PCB 07-01742-04
ASSY 00-05266-001

CODAN			SCALE	© CODAN PTY. LTD. A.C.N. 087 508 685, 1998				
	DRAWN	ILT	DATE	TITLE					
MATERIAL	CHKD	CRH	15-10-98	AUDIO INTERFACE					
FINISH	APPO	NJA	8-7-99	A1	DRAWING/DOC. NO				
	TOLERANCES				04-03109				
	UNLESS OTHERWISE STATED				ISS				
	2 PLACES DEC. *				3				
	1 PLACE DEC. *				SHIT 1				
ANGULAR ±			OF 1

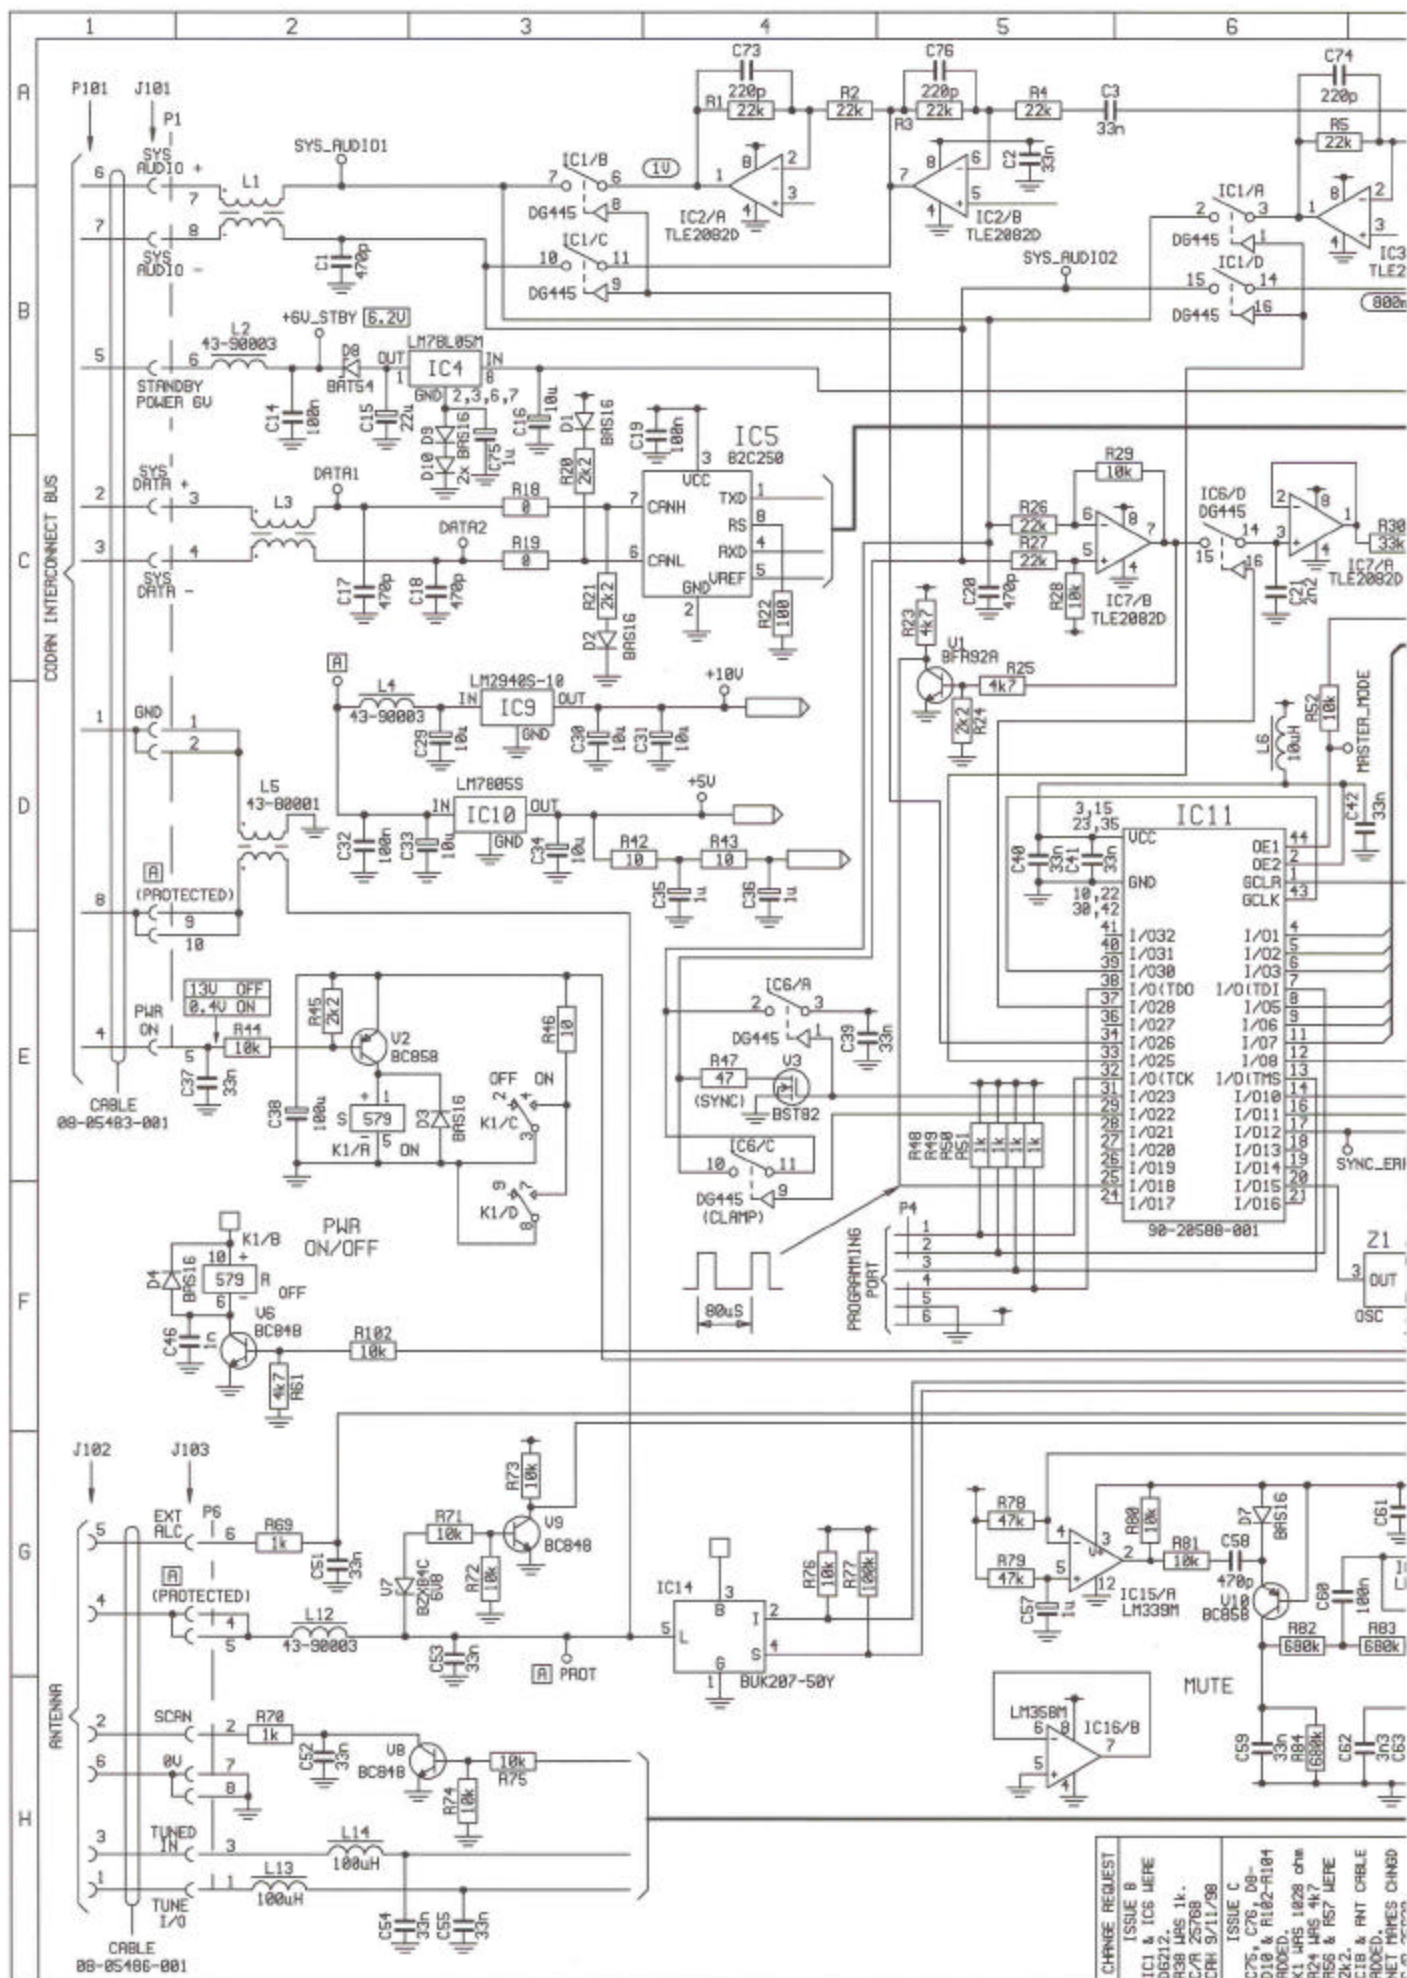
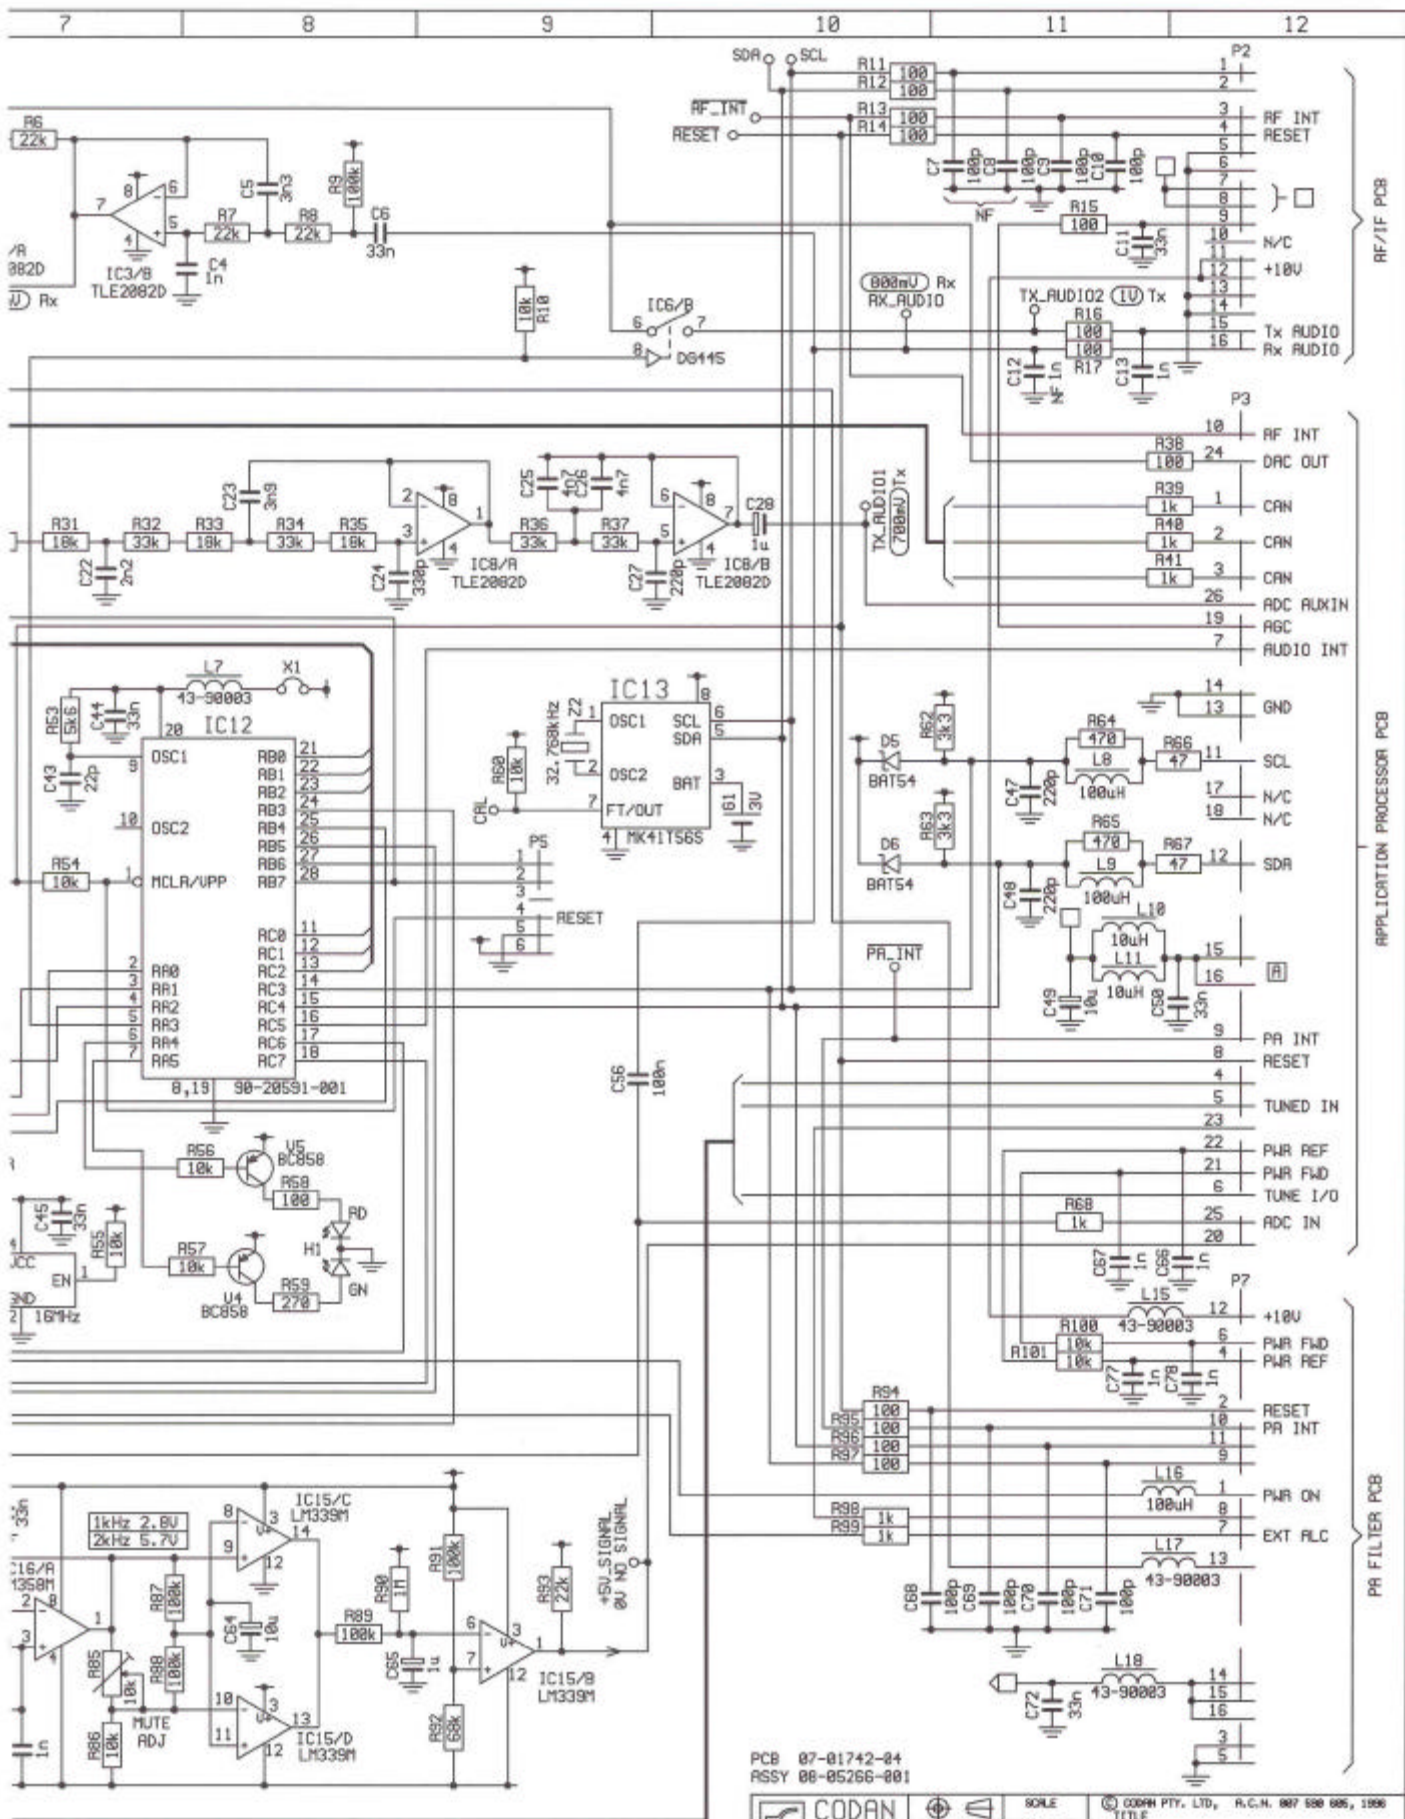
NJR 2-3-99	ISSUE D		NJR 1-7-99	ISSUE G		NJR 2-8-99	ISSUE 3		NJR 17-12-99	
	C77 & C78 ADDED C66 & C67 WERE 33n. LS MPS 43-90003 & MOVED ACROSS SUPPLY C/R 13/2/99			C13 MPS 33n. C/R 26/25 NJR 4-6-99			C16 MPS 220F. C/R 26/27 NJR 2-8-99			
NJR 1-7-99	ISSUE E		NJR 1-7-99	ISSUE F		NJR 1-7-99	ISSUE 2		NJR 1-7-99	
	C13 MPS 33n. C/R 26/25 NJR 4-6-99			TEST VOLTAGES ADDED. C/R 26/10 NJR 1-7-99			UNDERSCORES, DASHES & (...) REMOVED FROM NAMES ON RHS. C/R 26/27 NJR 2-8-99			
NJR 1-7-99	ISSUE F		NJR 1-7-99	ISSUE G		NJR 1-7-99	ISSUE 4		NJR 1-7-99	
	C13 MPS 33n. C/R 26/25 NJR 4-6-99			R103 & R104 DELETED. C/R 26/10 NJR 1-7-99			C16 MPS 220F. C/R 26/27 NJR 2-8-99
